BRUNSWICK STEAM ELECTRIC PLANT, UNIT NOS. 1 AND 2  
DOCKET NOS. 50-325 AND 50-324/LICENSE NOS. DPR-71 AND DPR-62  
REVISION TO PLANT EMERGENCY PROCEDURES

OPEP-02.6.29, "Activation and Operation of the Joint Information Center," Revision 4:

**0PEP-02.6.29**

***ACTIVATION AND OPERATION OF THE JOINT  
INFORMATION CENTER (JIC)***

ATTACHMENT 2  
Page 1 of 1  
**Joint Information Center (JIC) Recommended Layout  
(Command Room)**

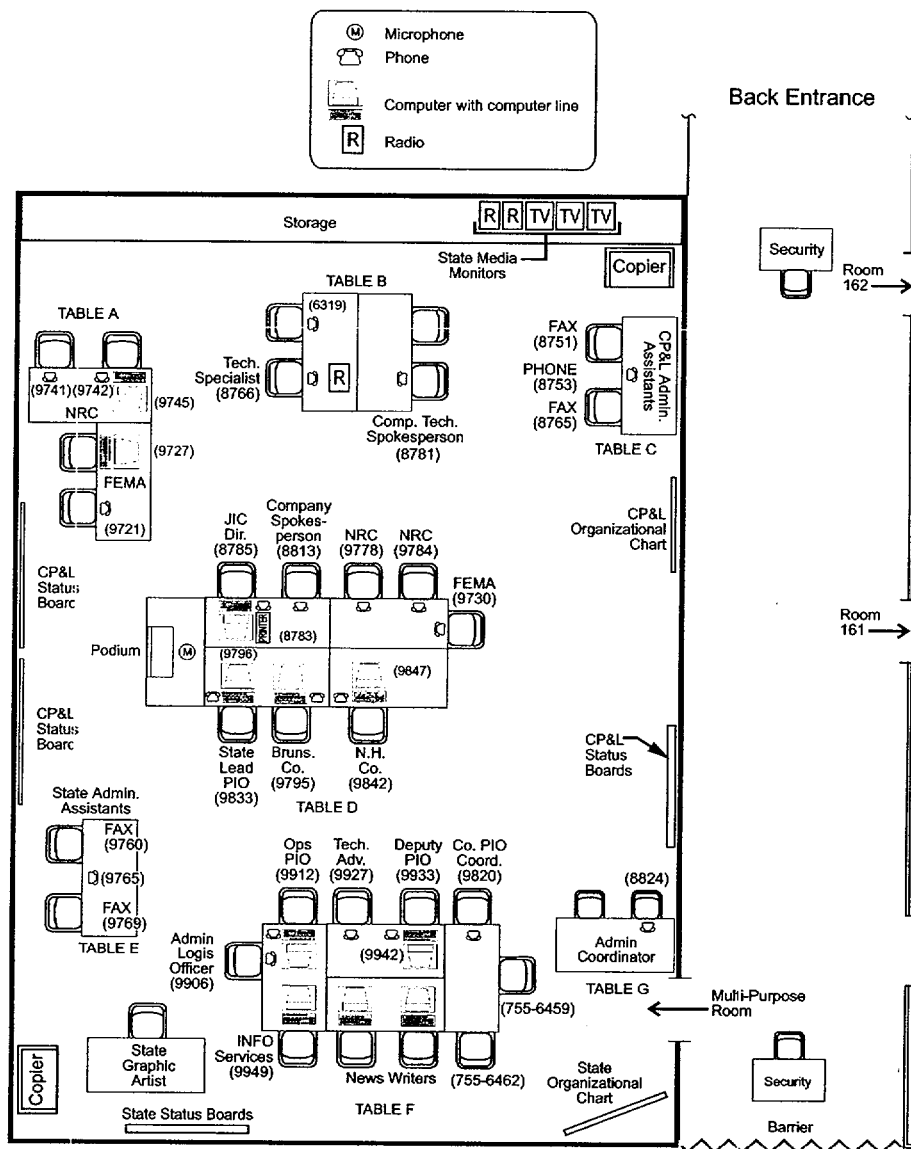
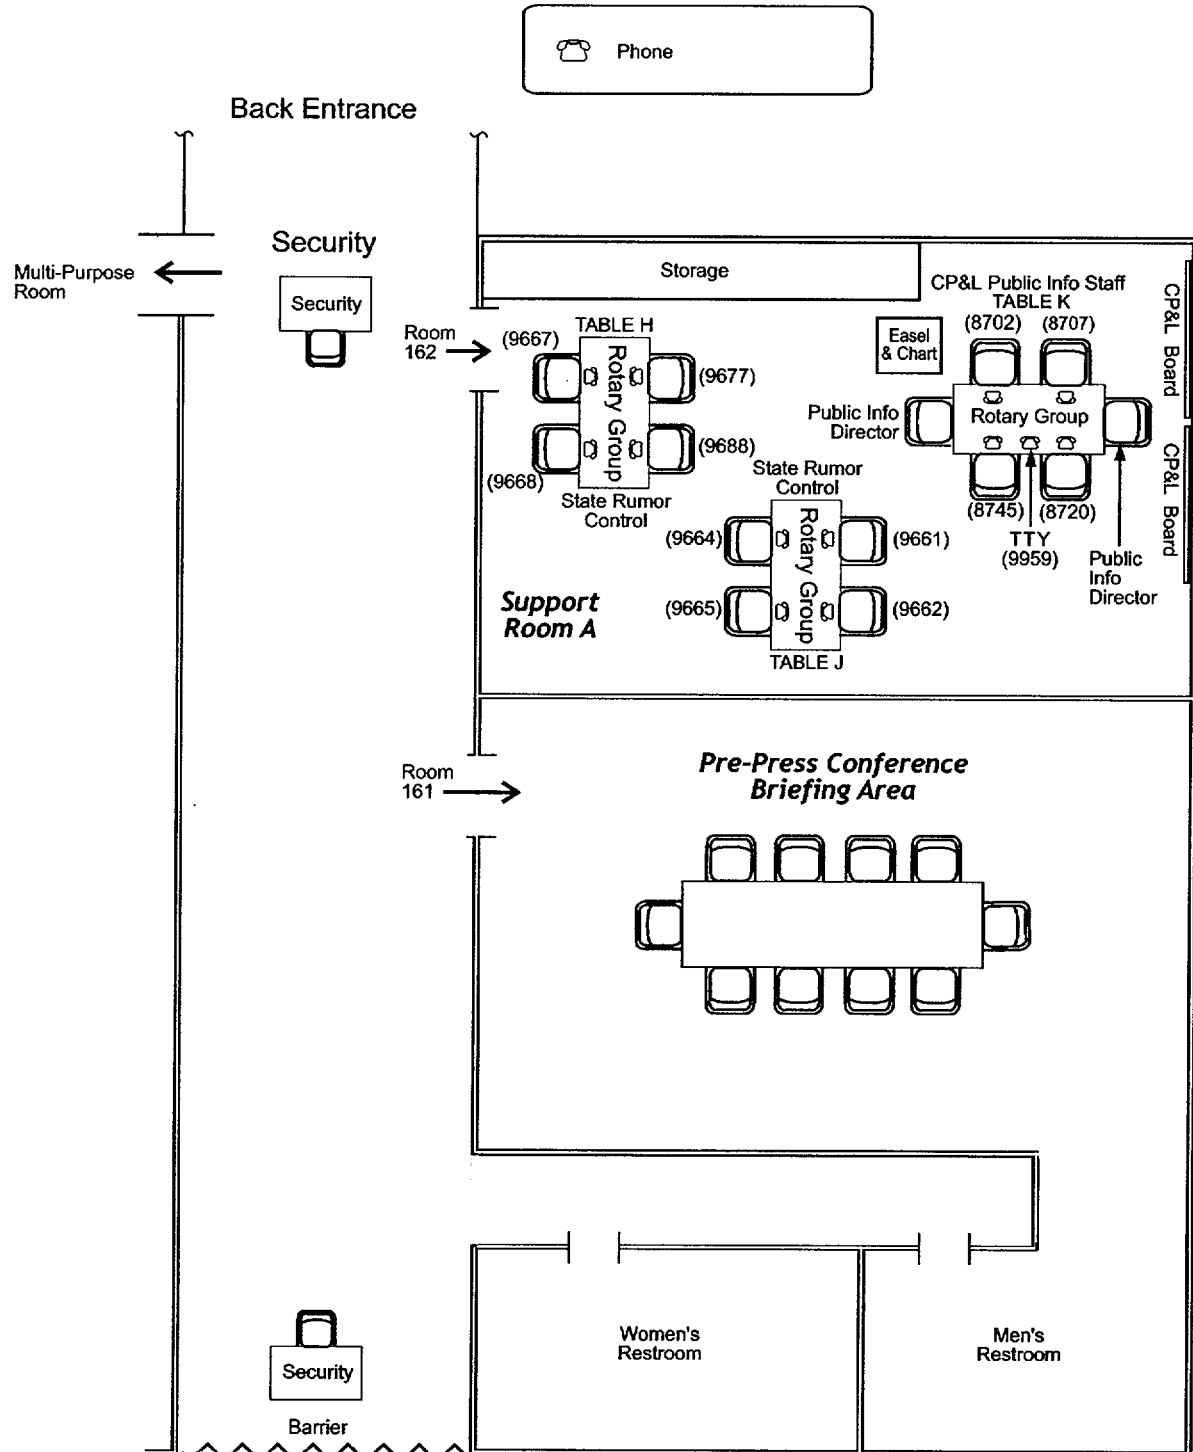
13. Corrected Attachment 2, JIC Recommended Layout (Command Room), and Attachment 3, JIC Recommended Layout (Support Room), to describe location of security access control points; deleted reference to radio on Technical Specialist worktable; and corrected typographical errors.

14. Added telephone line to Table B and additional chairs/phone lines at Table F for extra JIC personnel, if necessary.
15. Corrected typographical error in Attachment 5, JIC Set-Up Equipment, Item 9 by changing "CP&L" to "State."

19. Added note to Attachments 2 and 3 referencing prefix needed for phone extensions.
20. Added note prior to Section 5.5.7 to describe that the cafeteria area on the first floor of the Administration Building can be used as news media overflow area.

NOTE: Use prefix "754" for all phone extensions except Table F telephones indicated above (which are additional lines used as necessary).
